UNITED STATES PATENT AND TRADEMARK OFFICE

APPLICATION NO.	FILING DATE	FIRST NAMED INVENTOR	ATTORNEY DOCKET NO.	CONFIRMATION NO.
10/659,145	09/10/2003	Marie Ann McMasters	GE126465	3043
29827	7590	01/24/2005	EXAMINER	
FRANCIS L. CONTE, ESQ. 6 PURITAN AVENUE SWAMPSCOTT, MA 01907			KIM, TAE JUN	
			ART UNIT	PAPER NUMBER
			3746

Office Action Summary

DETAILED ACTION

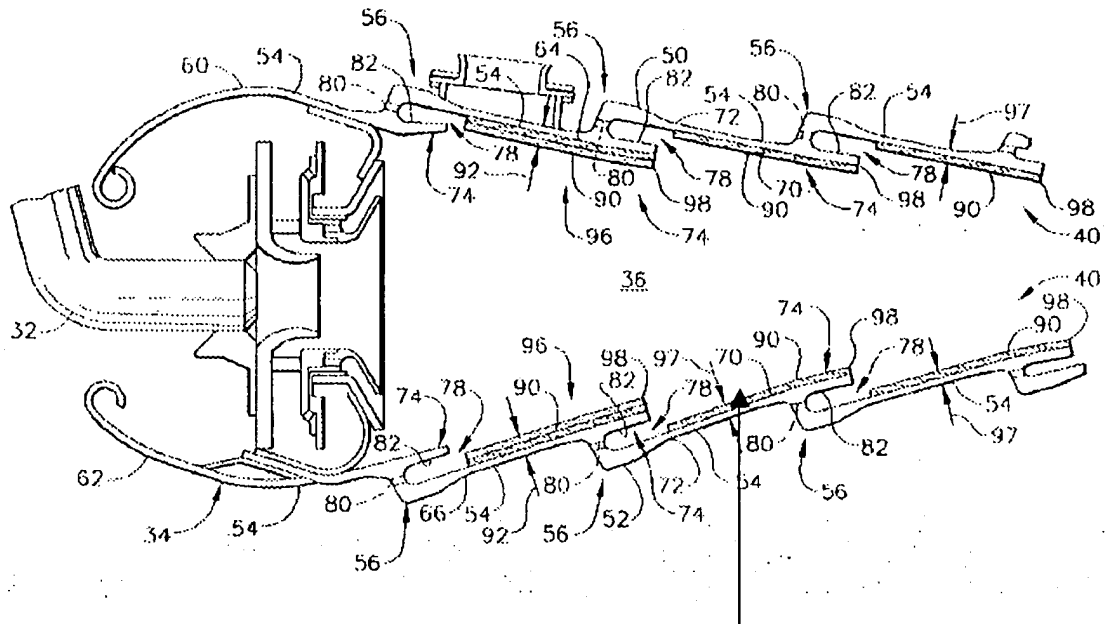
1. The drawings are objected to under 37 CFR 1.83(a). The drawings must show every feature of the invention specified in the claims. Therefore, the drawings must show “said lip having a distal end at said slot outlet being spaced from said coating aft of said slot (B) less than about said coating nominal thickness (A)” must be shown – see also paragraph [0031] of the specification. The drawings show the opposite relationship of B to A from that claimed and disclosed. No new matter should be entered.

McCaffrey et al teach that layer 90, 96 can be applied to all the panels 54 with the same thickness T_1 and when that is met, the said lip having a distal end at said slot outlet is spaced from said coating aft of said slot less than about said coating nominal thickness

Corrected drawing sheets in compliance with 37 CFR 1.121(d) are required in reply to the Office action to avoid abandonment of the application. Any amended replacement drawing sheet should include all of the figures appearing on the immediate prior version of the sheet, even if only one figure is being amended. The figure or figure number of an amended drawing should not be labeled as “amended.” If a drawing figure is to be canceled, the appropriate figure must be removed from the replacement sheet, and where necessary, the remaining figures must be renumbered and appropriate changes made to the brief description of the several views of the drawings for consistency. Additional replacement sheets may be necessary to show the renumbering of the remaining figures. The replacement sheet(s) should be labeled “Replacement Sheet” in the page header (as per 37 CFR 1.84(c)) so as not to obstruct any portion of the drawing figures. If the changes are not accepted by the examiner, the applicant will be notified
